**ACT**  
Government

Environment, Planning and  
Sustainable Development

**Further information request – DA-202442900 – Block 76 Section 10 Garran**

Image 1

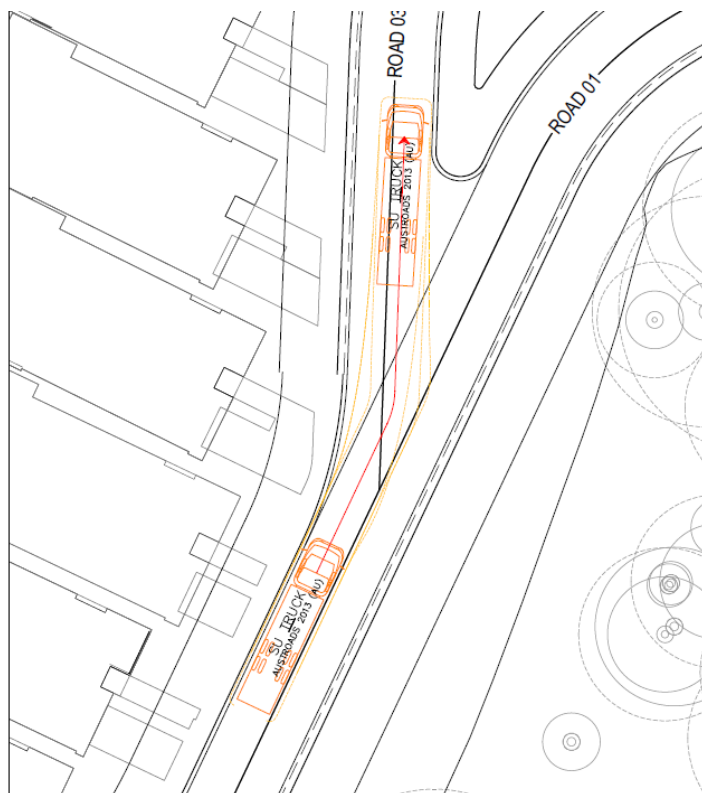
9. New paths link must comply with a minimum width of 1.5m, therefore, the proposed path link along Kitchener Street must be at least 1.5m.
10. Also, there is a road safety issue with crossing Kitchener Street where some sort of pedestrian crossing facility will need to be provided as shown in Image 1 below.
11. Please inform to the applicant to confirm a 4m unobstructed carriage way along the intersection on Kitchener Street (both sides of the road).
